Solicitation Addendum

Addendum No.: 2

Solicitation Title: Phase 1 of Seacrest Beautification

Addendum Date: August 28, 2017

TYPICAL 50' R/W SECTION WITH SWALE
DETAIL RT 1.1b

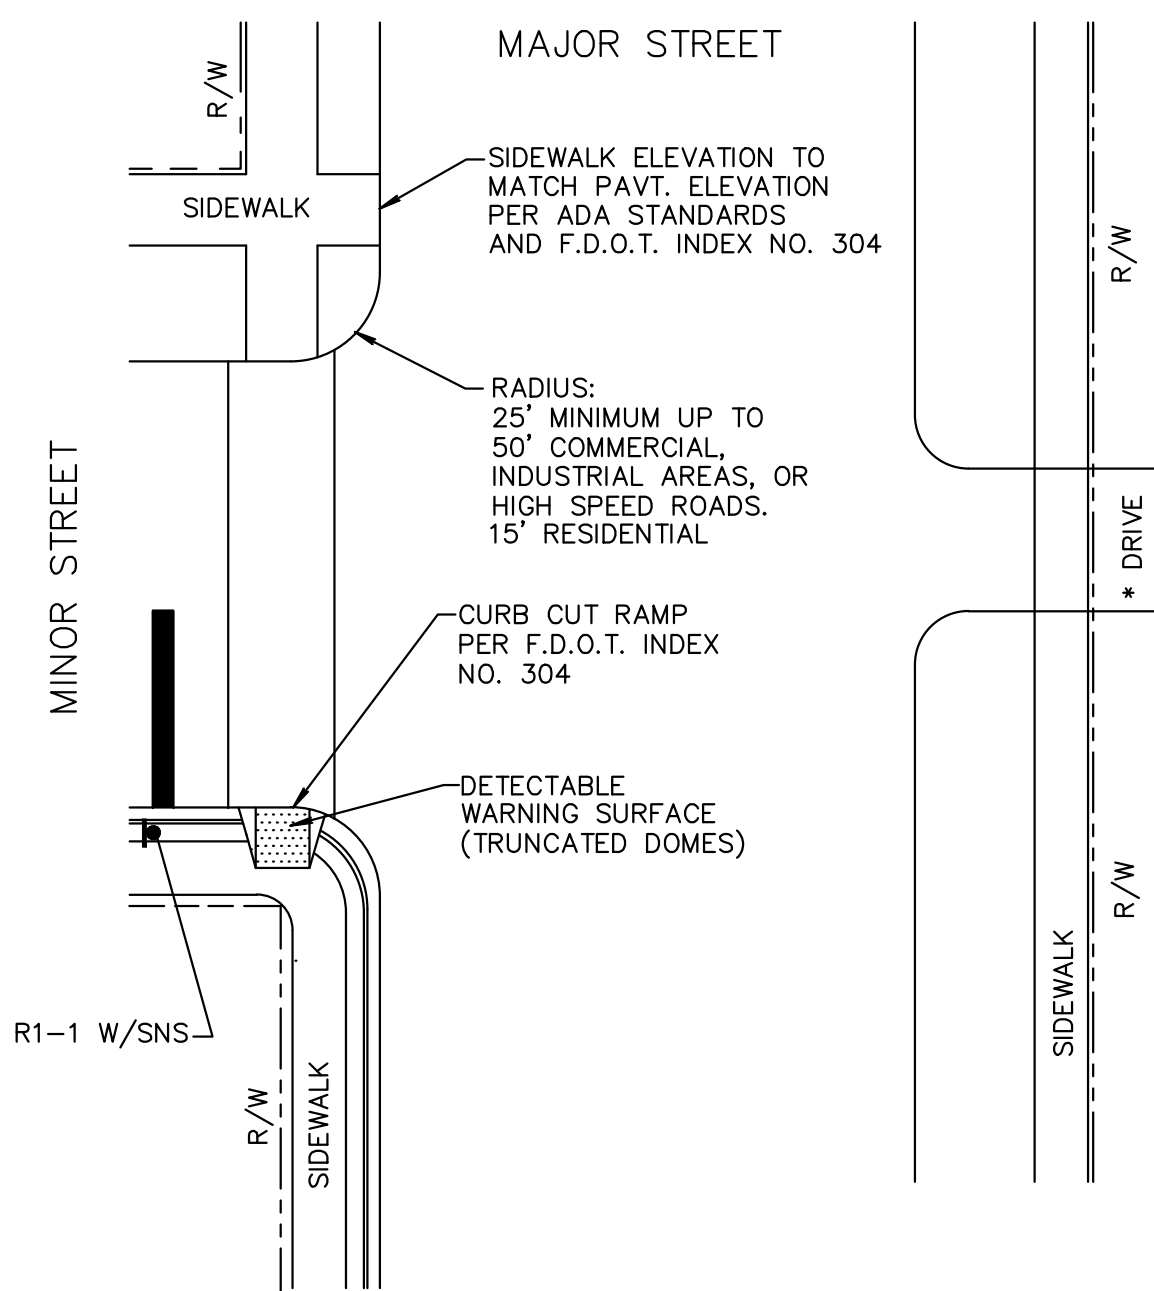
- Q10. Sheet C-26, Typical 50' R/W Section with Swale Detail RT 1.1b. – This detail shows an 11-12' Lane, a 7' MINIMUM Swale, and a 5' Sidewalk and a 1' Green Strip for a total width of 25' on either side of the centerline. Unfortunately the 4' Bike lane is not included in this detail, which makes constructing a MINIMUM 7' swale, impossible. 10' Lane, 4' Bike Lane, 7' min Swale, 5' sidewalk is already 26'. Please clarify this detail. We cannot construct a 7' Swale minimum width in the 50' R/W.

- R10. Sheet C-26 is revised per this Addendum No. 2.**
- Q11. Sheet C-27, Minimum Layout Standard for Duplex Parking RT 9.3 - These Details show work outside the Right Of Way (ROW). Please clarify the intent of this detail. Are there any locations where the installation of parking outside of the ROW line is required? Are there construction Easements in place for this work? If no easements are in place, will Delray Beach be procuring these agreements?

EROSION CONTROL NOTES DETAIL D9.1

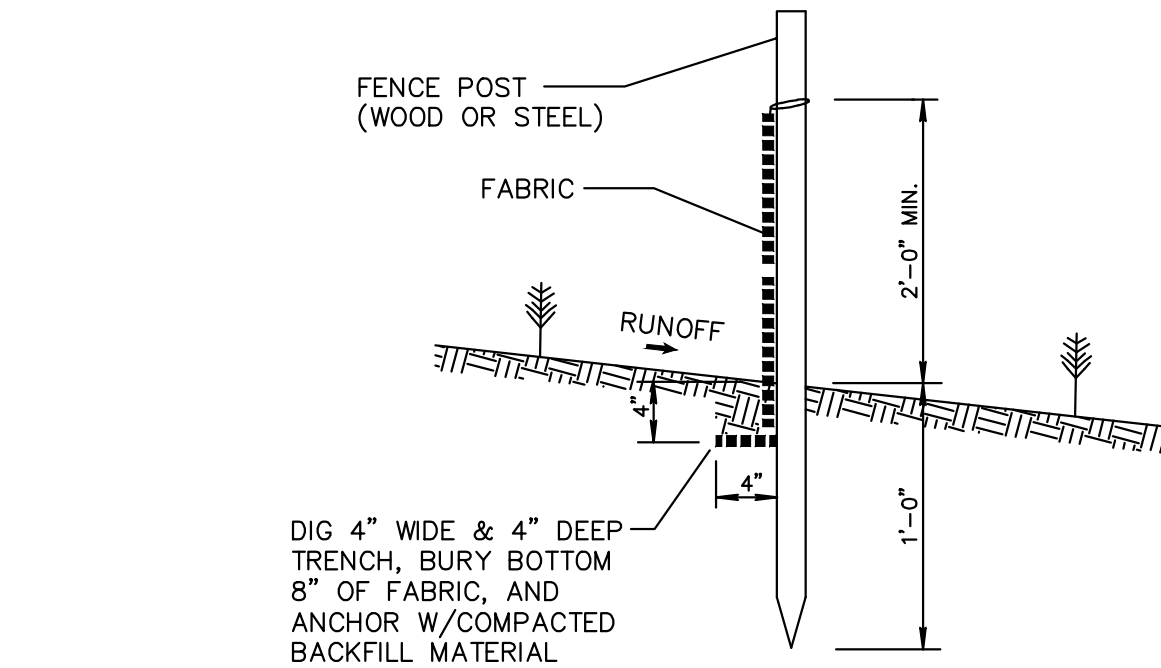
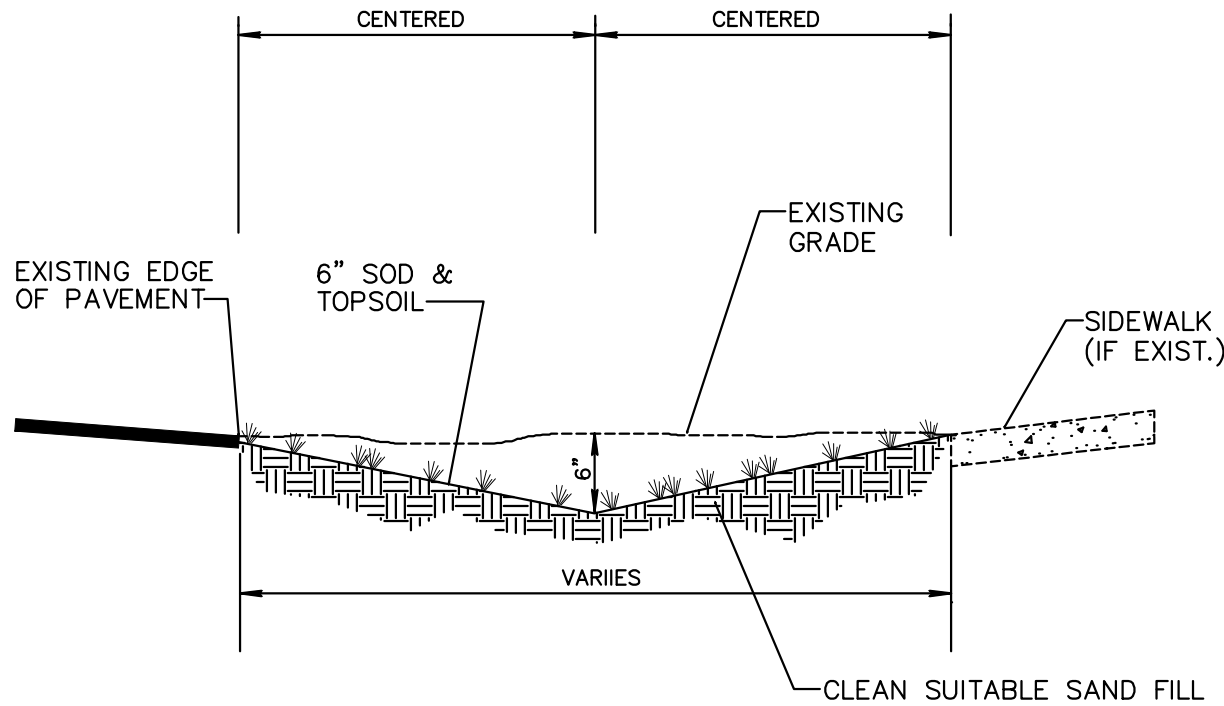
- Q1. Sheet C-28, Stabilized Construction entrance Detail D9.1C - The Note states "A Construction Entrance Shall be Constructed...." The wording makes this a required component. Please identify where we are to construct a 50' Minimum length Construction Entrance on the site, and what Pay Item should we include this in?
- R1. **This detail is removed. Please see revisions made to Sheet C-28 per this Addendum No. 2.**
- Q2. Is the City allowing for an optional base group on the widening, or is it limited to limerock base?
- R2. **No, an optional base group will not be accepted.**
